184-194 CORN STREET

Alterations at 190 Coyle Street for Albert Mitchell

Subject: Building permit for alterations in the
single family dwelling house at 1950 Cole Street
to be a second apartment on the third floor

Subject: Application for permit for providing a single apartment in third story of one family dwelling house at 190 Coyle Street, thus making two apartments in entire building.

FRAMING OF 3RD FLOOR
PLAT FORM FOR REAR
STAIRS.

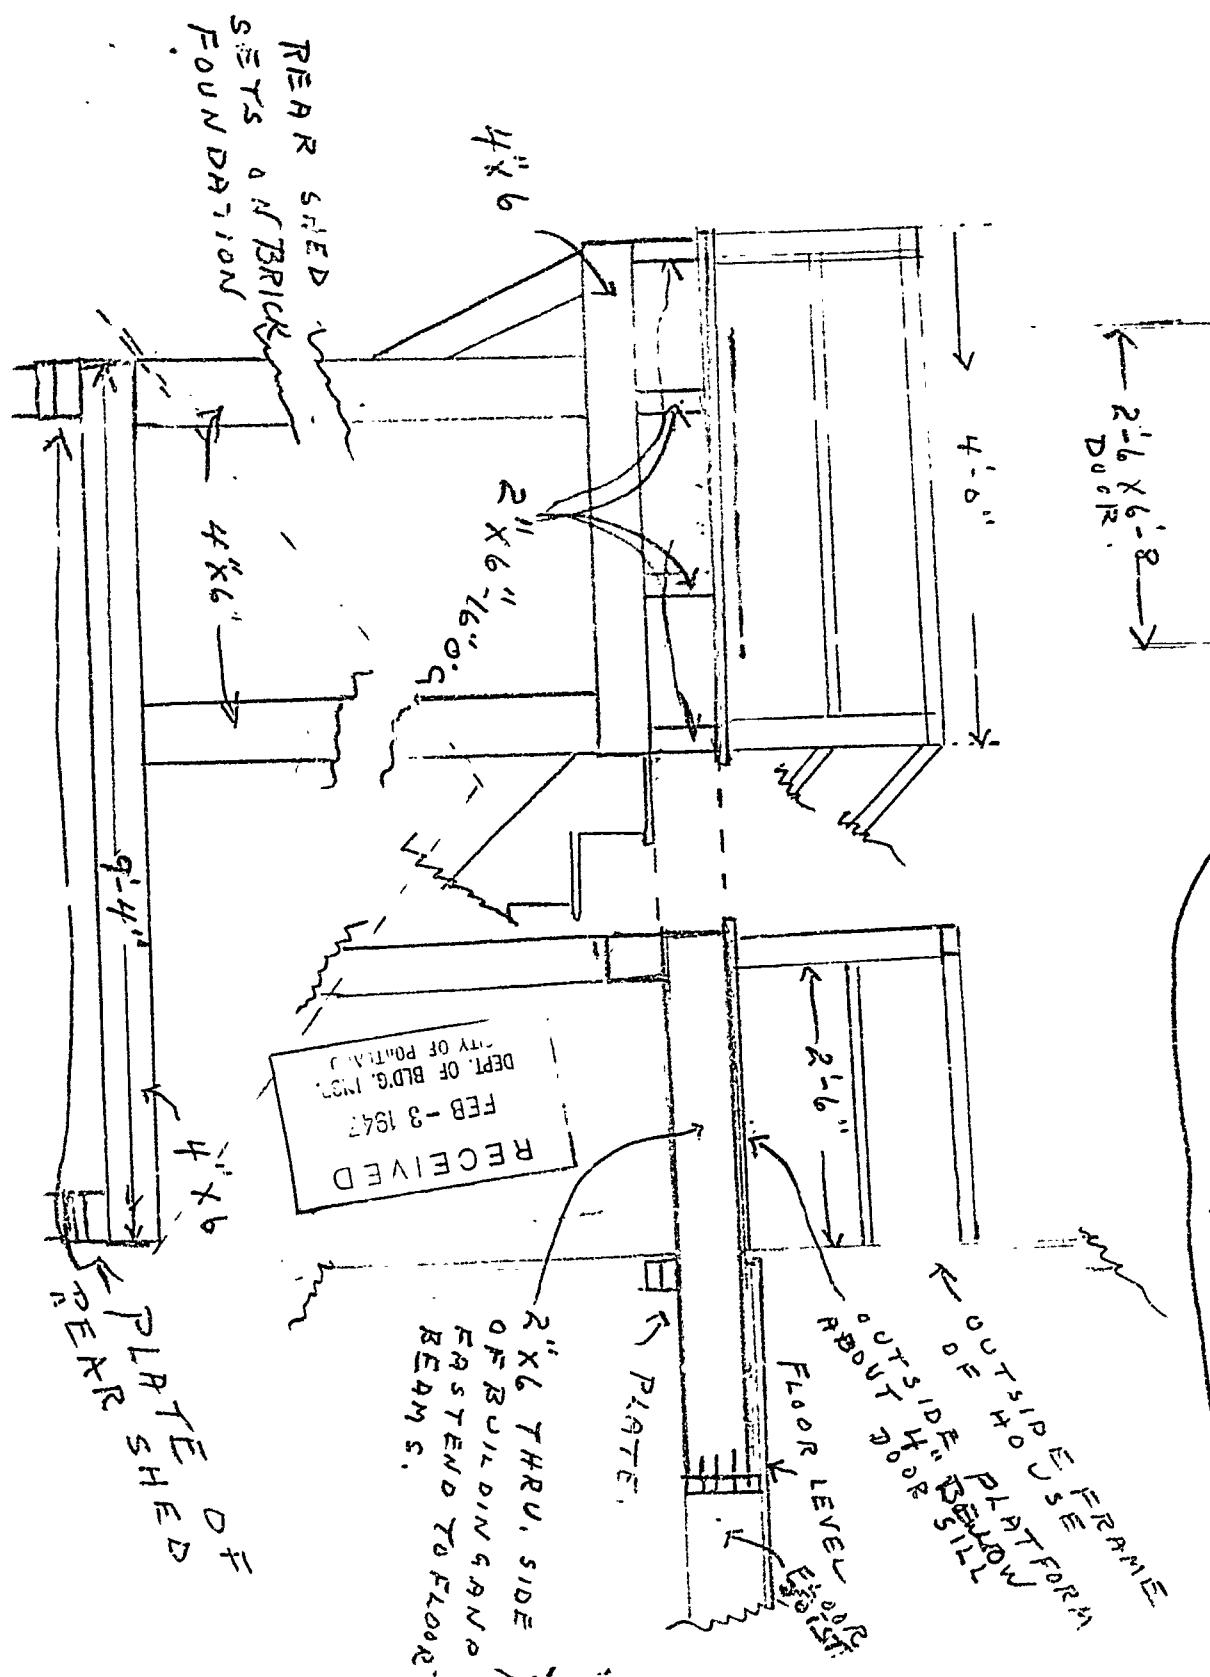
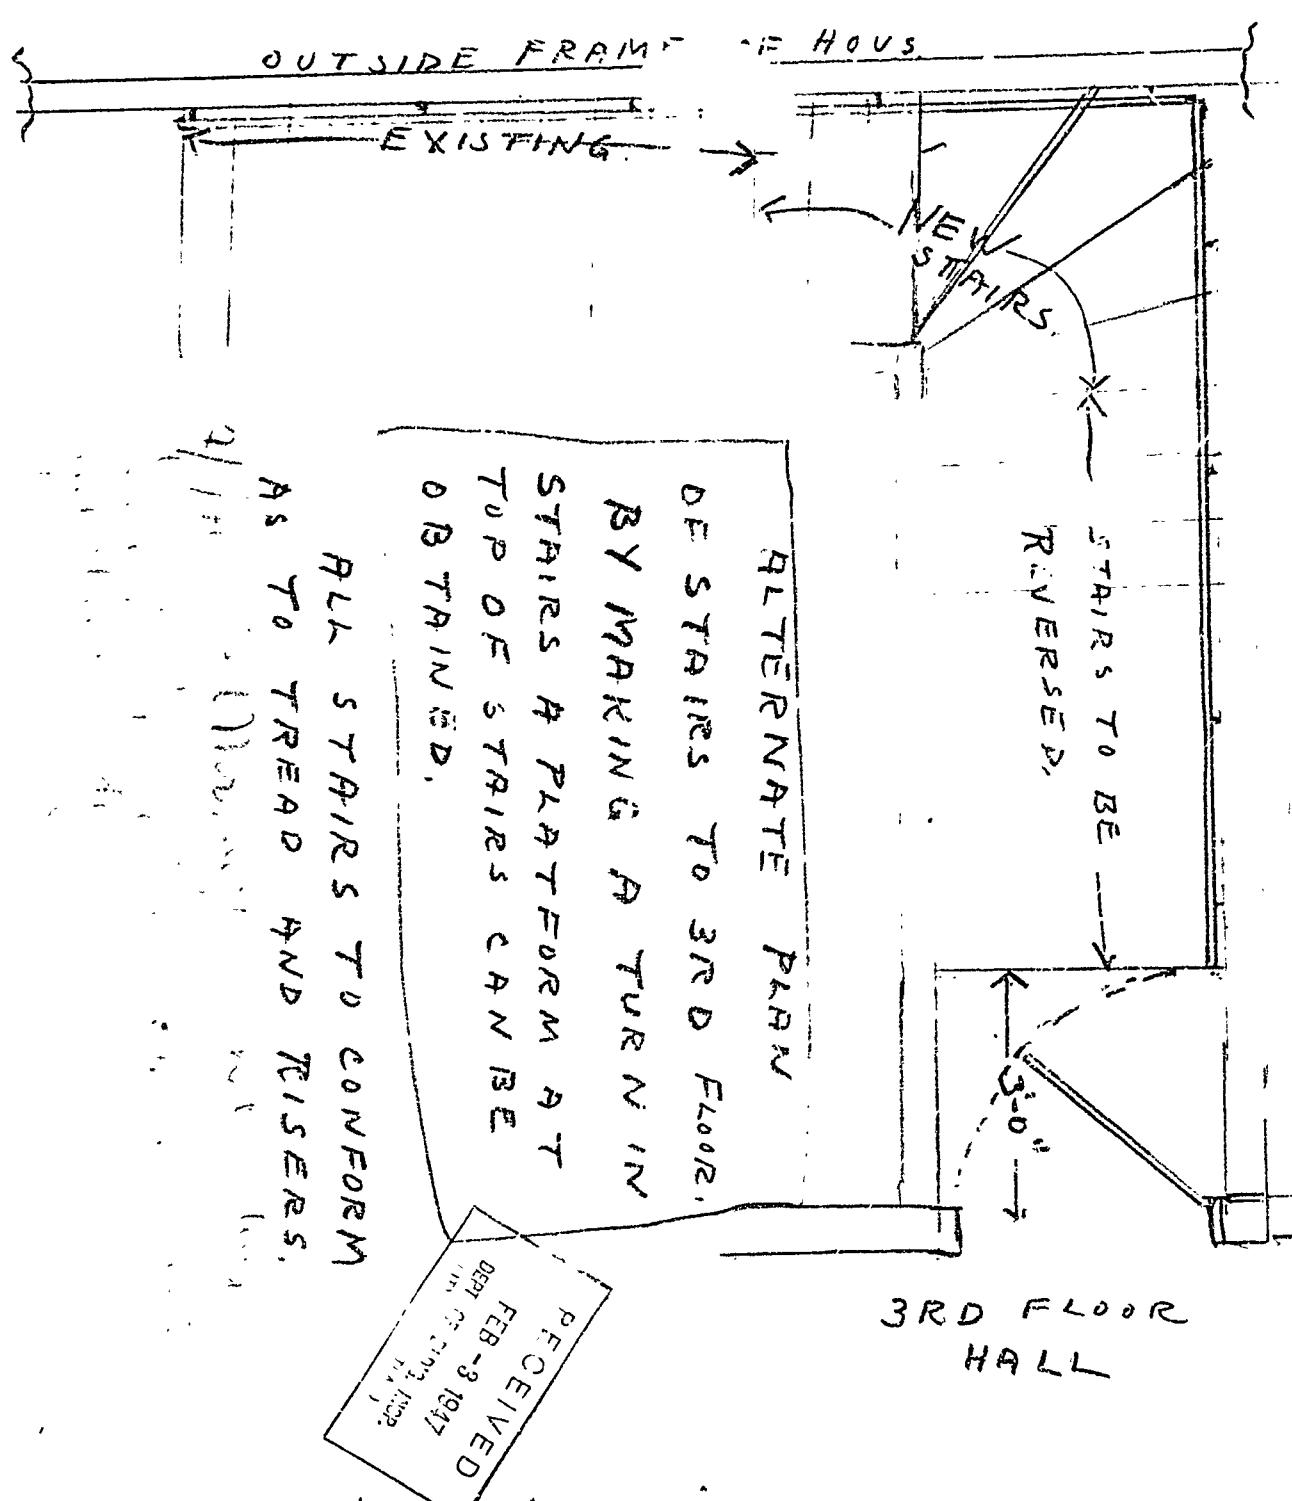
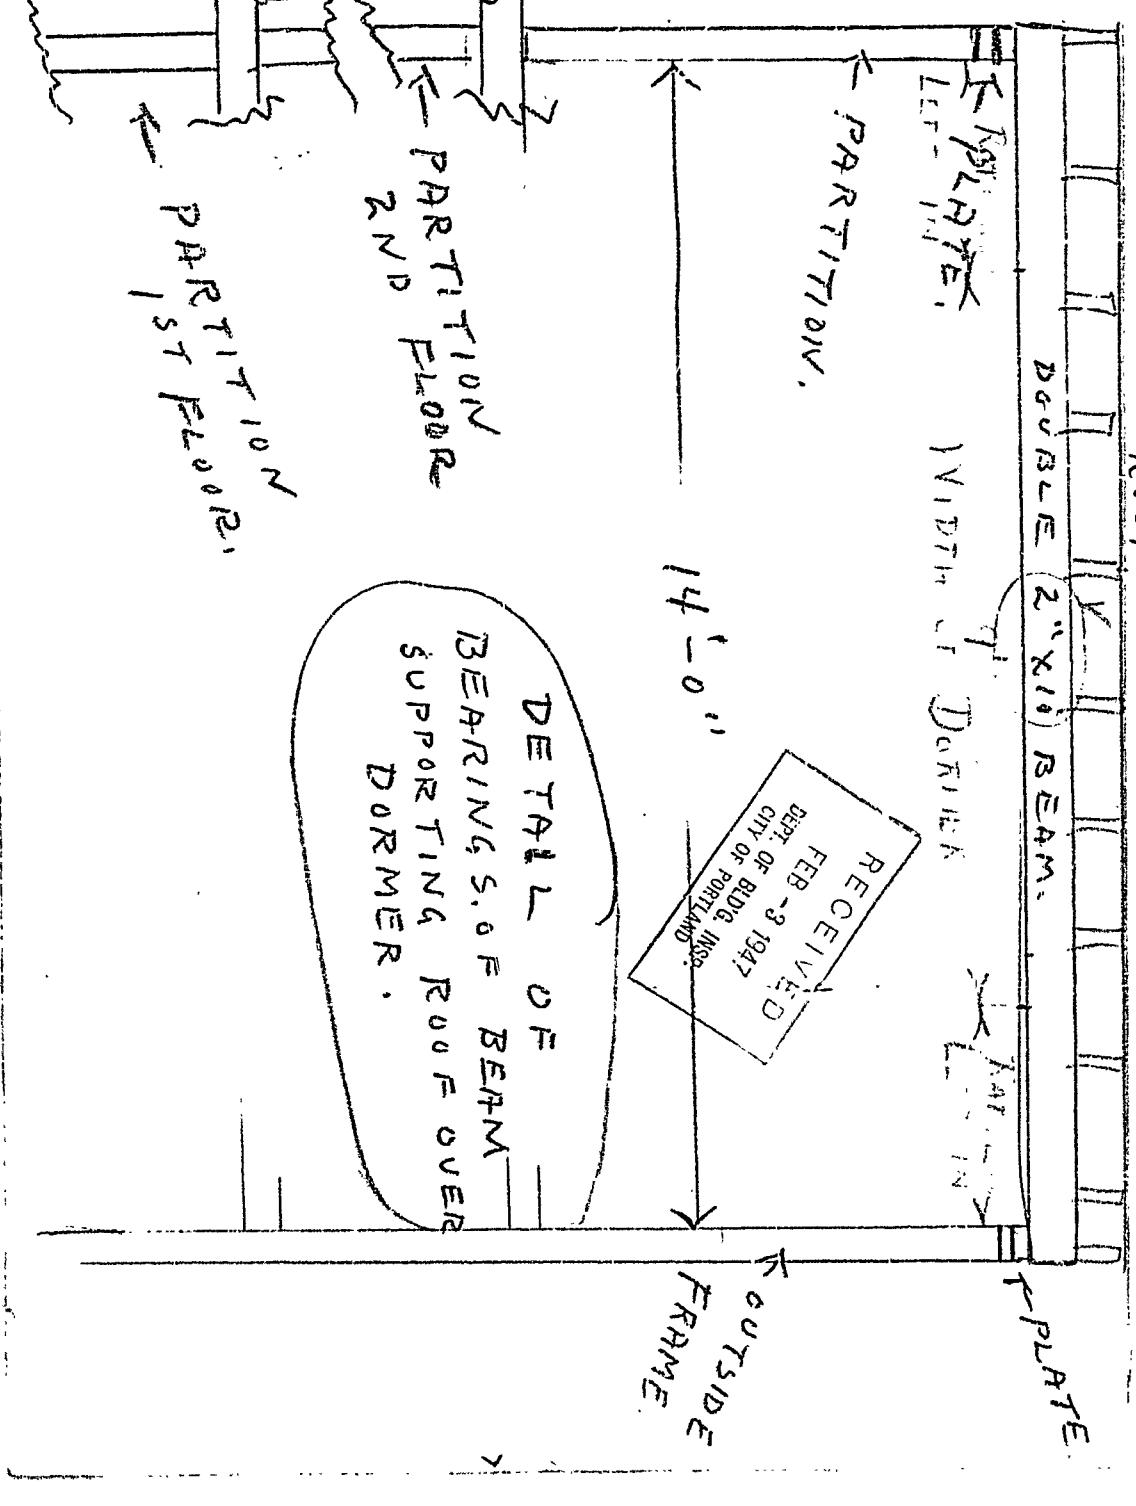
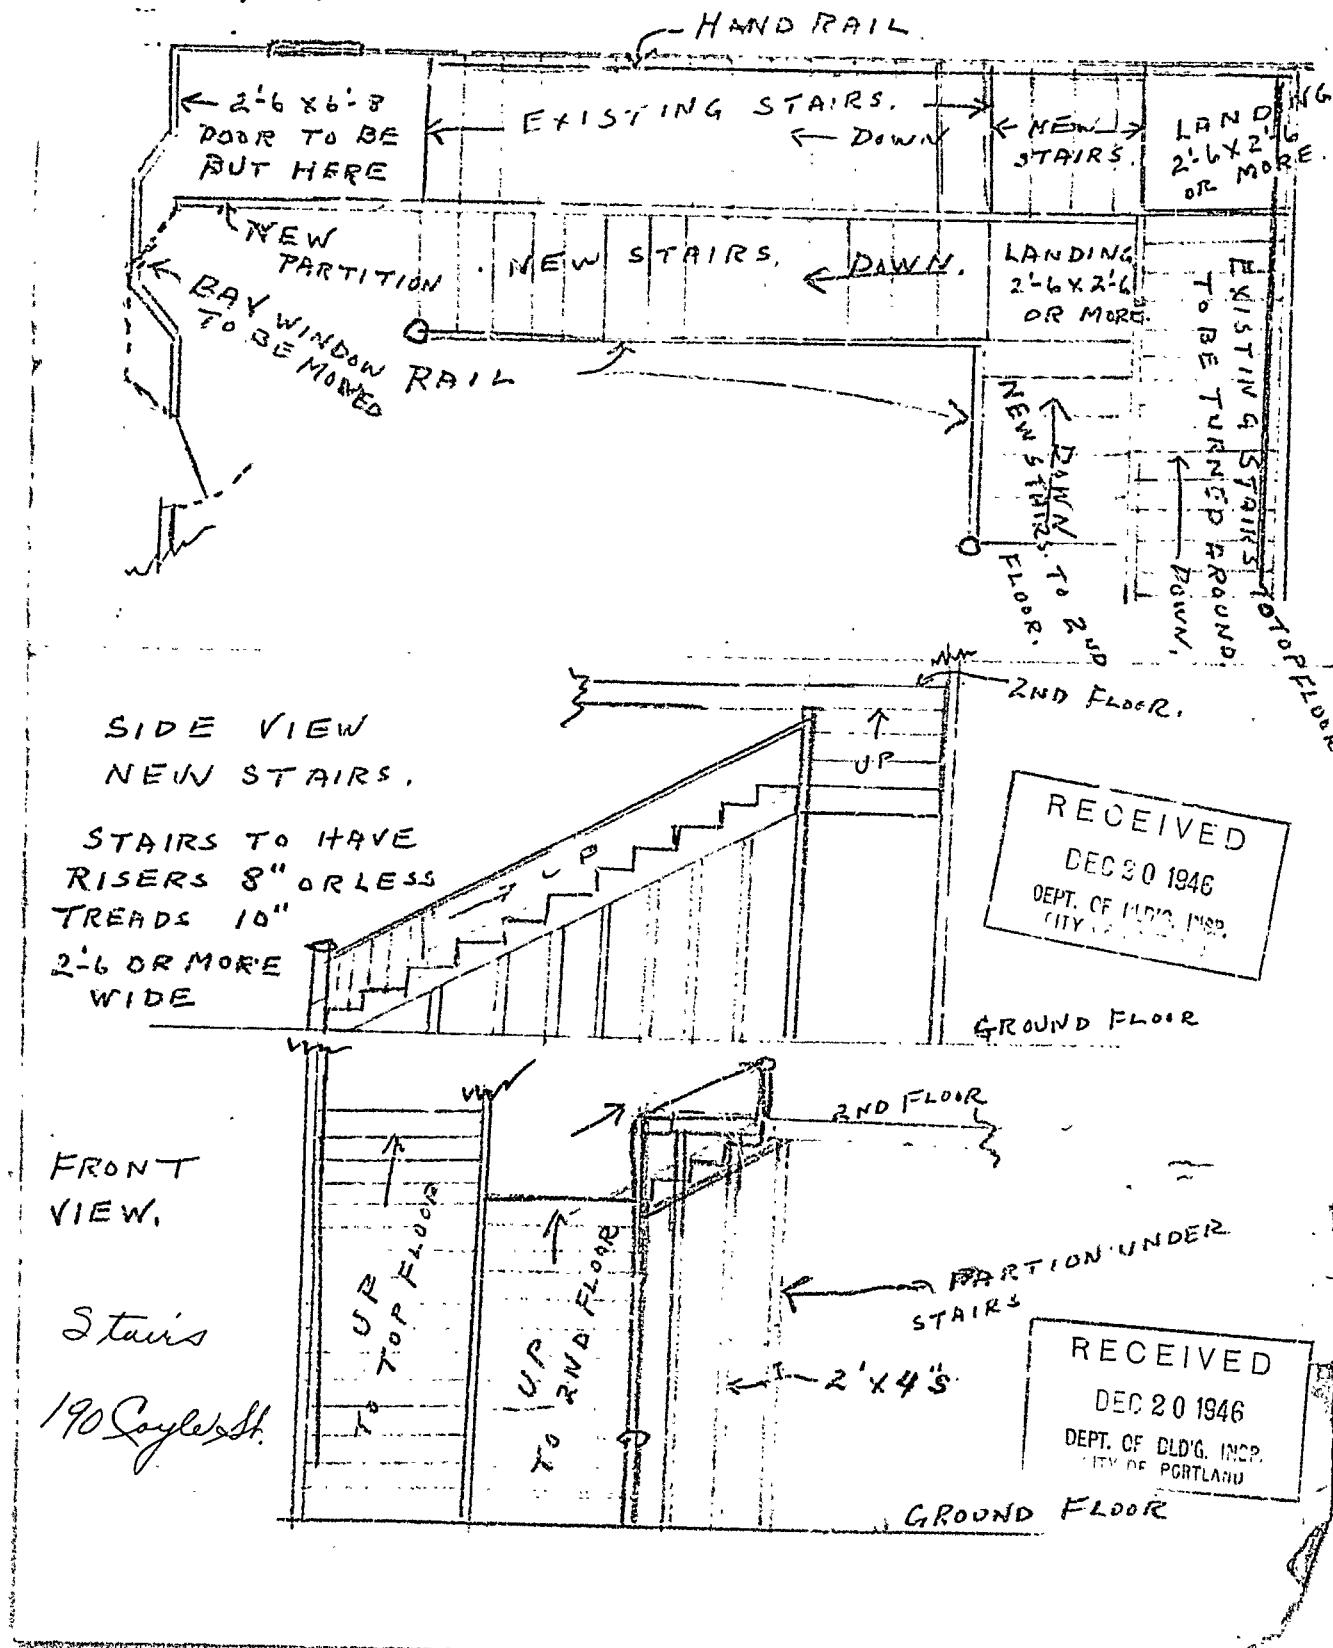
Page 1, Art. 4.

By building a turn in stairs to 3 rd. floor I can get a platform and door at top of stairs, I am submitting a sketch of same, hoping that this meets with your approval.

Page 2, Art. 6.

I am submitting a sketch, showing bearings for the double 2x10 beam supporting inner ends of rafters of dormer window. I wish to advise that there is a partition under the inside end of this beam on both 1 st & 2 nd floors.

1. The revised plans of the new outside rear stairway shall show the following:

OK That the sill of the new doorway from third floor to the rear will be not more than 12 inches above the level of the same platform, and that an outside landing or platform will project beyond the doorway jam at least nine inches—from jam to the railing at one end and from the jam to the nosing of the top step at the other end.

OK Show what the foundations are of the present shed in which the upper run of stairs and rear platform will be located and if not in existence, these foundations will have to be made of stone and that should be covered in the plans.

OK Framing of upper platform should be clearly shown as to size, spacing of joists and the way supports them and which way the beams run. Probably this can be designed so the knee brace arrangement will not be necessary. We have had considerable difficulty checking these plans because they appear to be to scale in places and very much out of scale in others, especially with regard to the dimensions of the rear one-story end on which this stairway and platform would be supported. Therefore we cannot tell what's what. The 4x6 beam will have to support one post of the upper platform.

OK The outside 4x6 post should go clear down the side of the roof to rest either on the plate of the existing shed or upon the 4x6 toe which should in turn rest upon the plate.

6. We are unable to check the strength of the doubled 2x10 beam shown to support the inner end of the front dormer rafters. It is not clear on what span this beam will be. Examination of third floor plan indicates that this span would probably be 14 feet. Cross-section of dormer shows this beam to be let up into the existing rafters of the upper slope of present roof which would mean that this beam would have

to carry all of the load of present roof outside of the width of the proposed corner. Adding the walls together shows that the beam, if over a span of 4 feet, would have about 10,000 pounds over load.

The above amendment is issued herewith, but excluding the work on the outside rear stairway, which apparently cannot be worked out as shown on plans. We understand that further study of the situation is to be made and another amendment filed with plans when difficulties have been solved, perhaps by providing a metal fire escape instead of a wooden one.

Mr. DeGrasse agreed to provide 2-2x12's as a header to support rafters across opening for dormer window, but we find on further checking that 2-2x12's will be sufficient to take care of the load. We understand that an iron pipe column at least 4" in outside diameter will be provided in cellar beneath girder at location where the load from one end of this dormer window header will stand.

The new stairs from first to third stories are to be built without the use of winding treads and a landing at least 3' deep and a self-closing door is to be provided at head of stairs in third story. At the request of Mr. DeGrasse the removal of the stained glass window in the easterly wall of third story and its replacement by an ordinary window smaller in size has been included in work to be done under this amendment.
